Town of Ridgeland

PROJECT: Town of Ridgeland Water and Sewer Resiliency Improvements
TOR-2023-02

ADDENDUM: Three (3)

A10.3

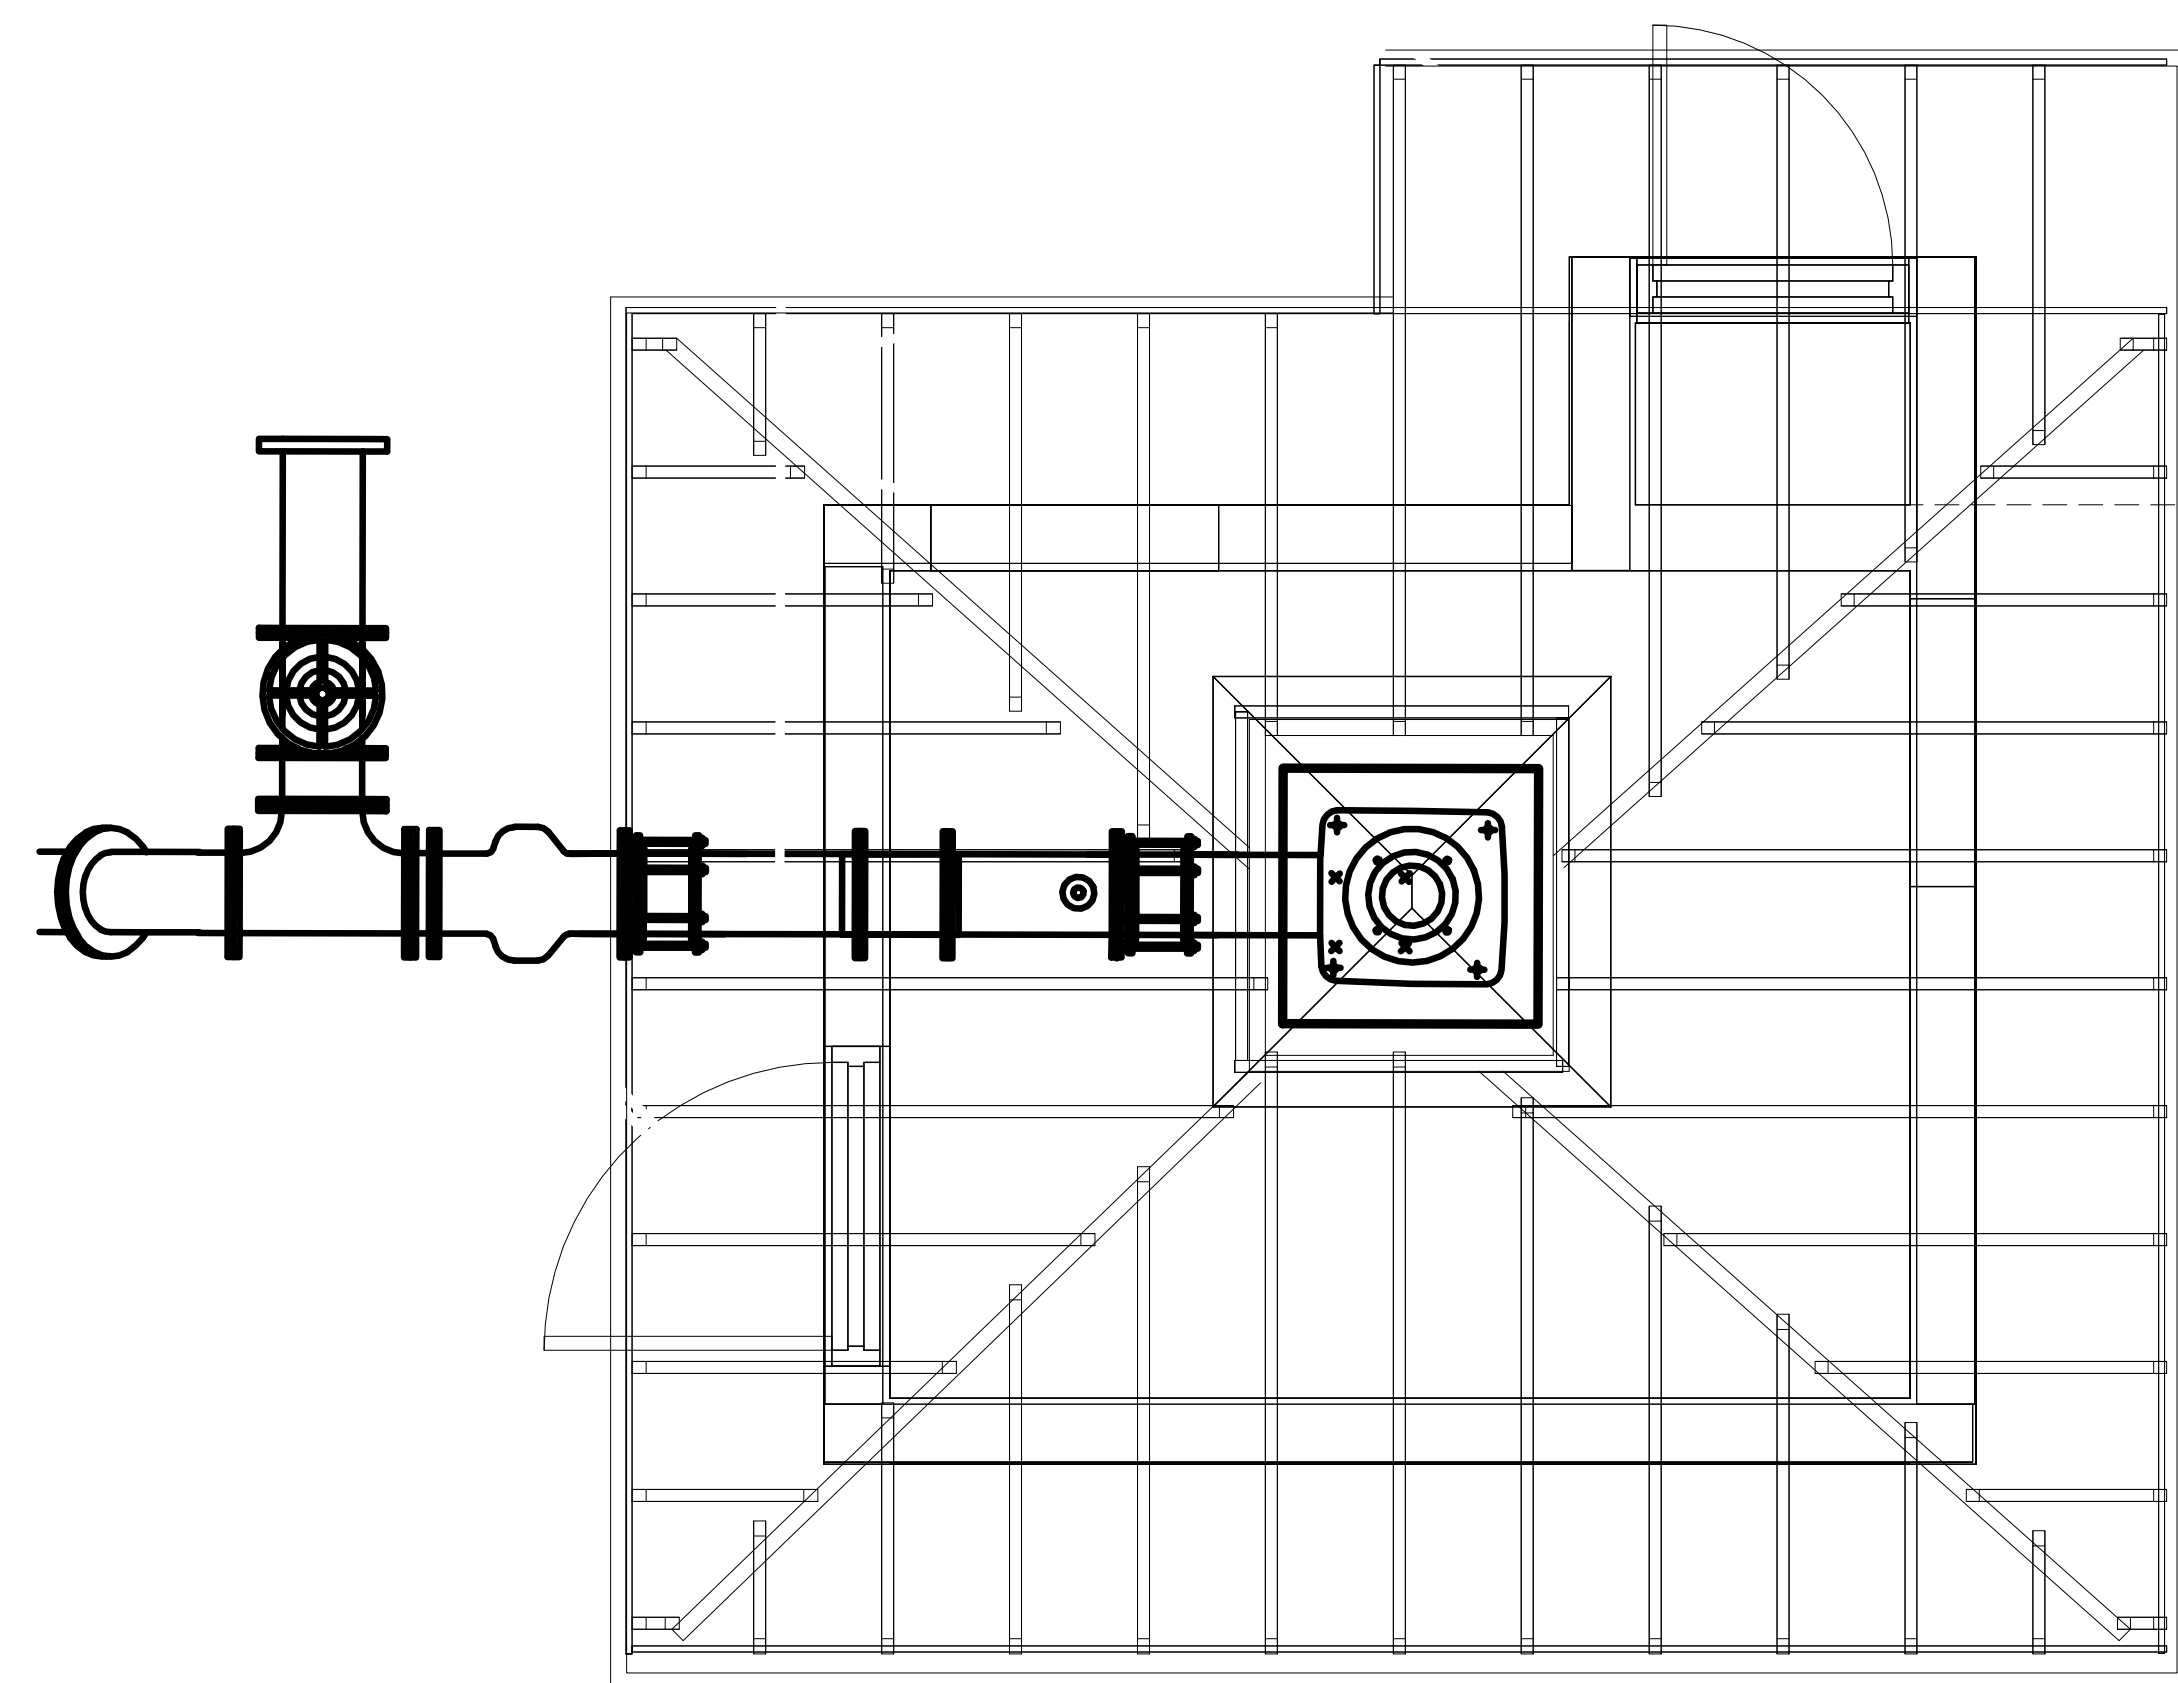
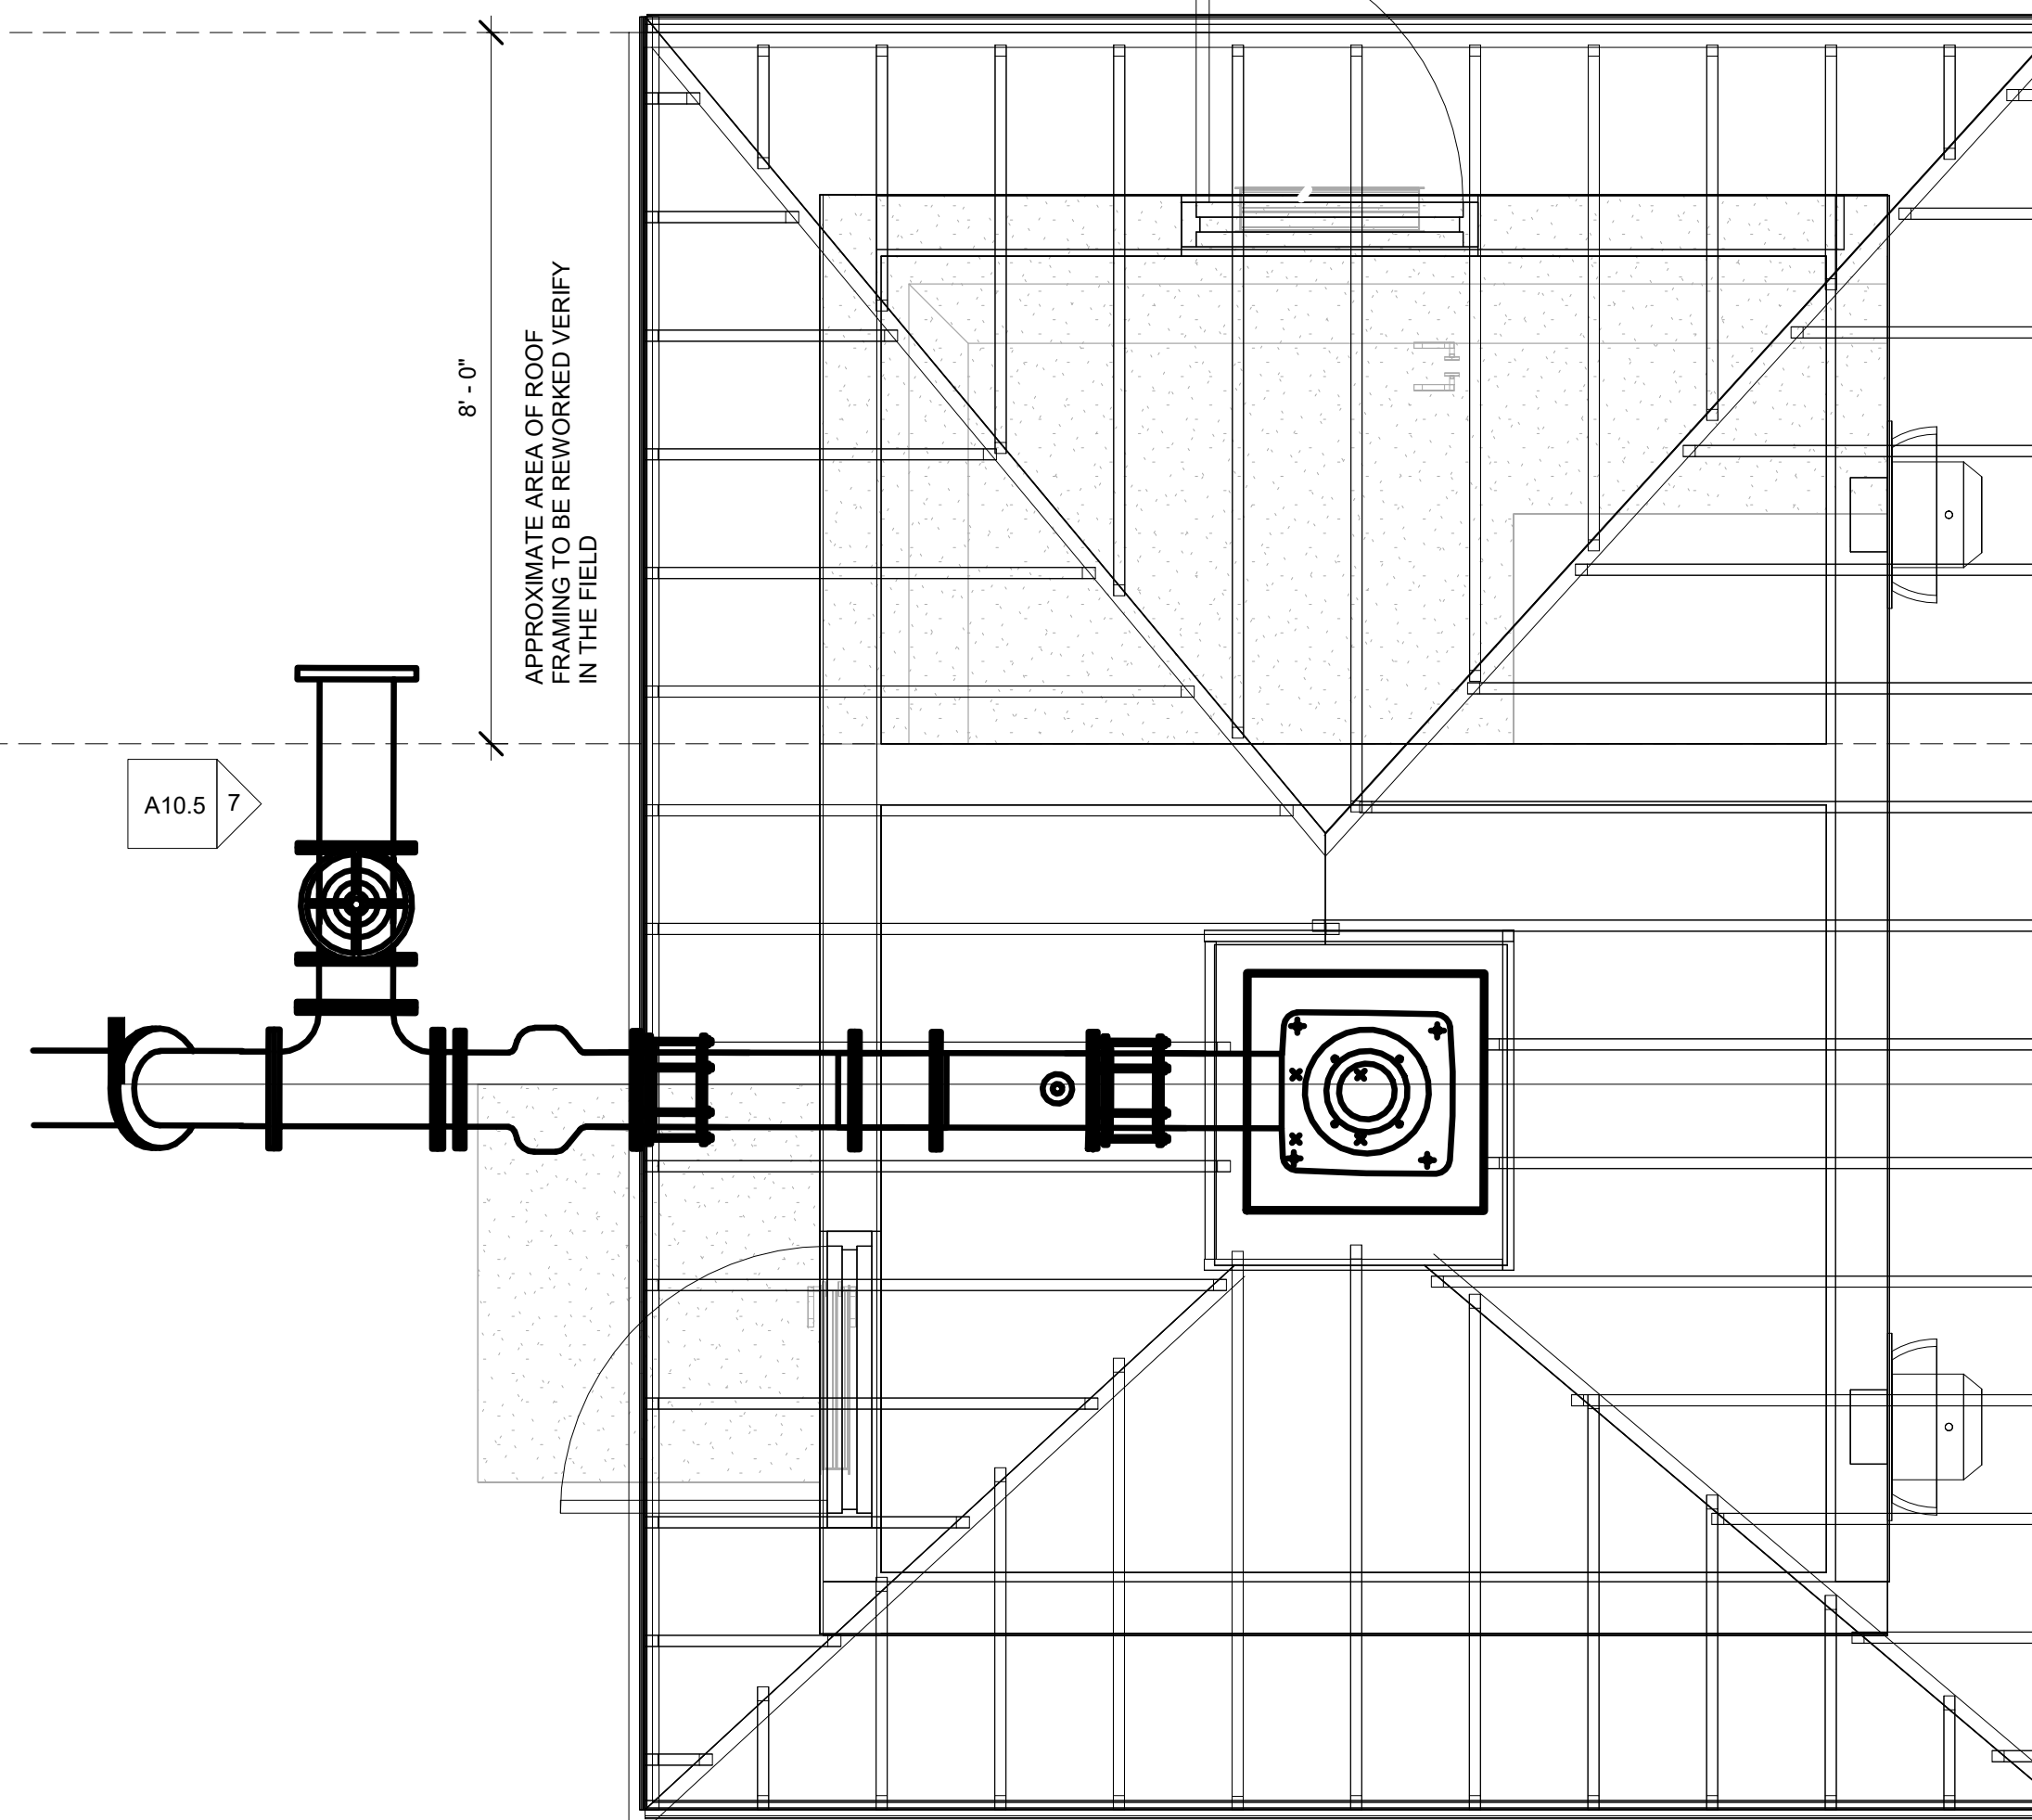
- i. A10, A10.1 – A10.7 Architectural improvements updates to correct dimensions of the existing building and to modify and increase the size of the proposed building expansion for the chemical room.
- ii. S100, S101, and S201 Structural improvements updates to correct dimensions of the existing building and to modify and increase the size of the proposed building expansion for the chemical room.
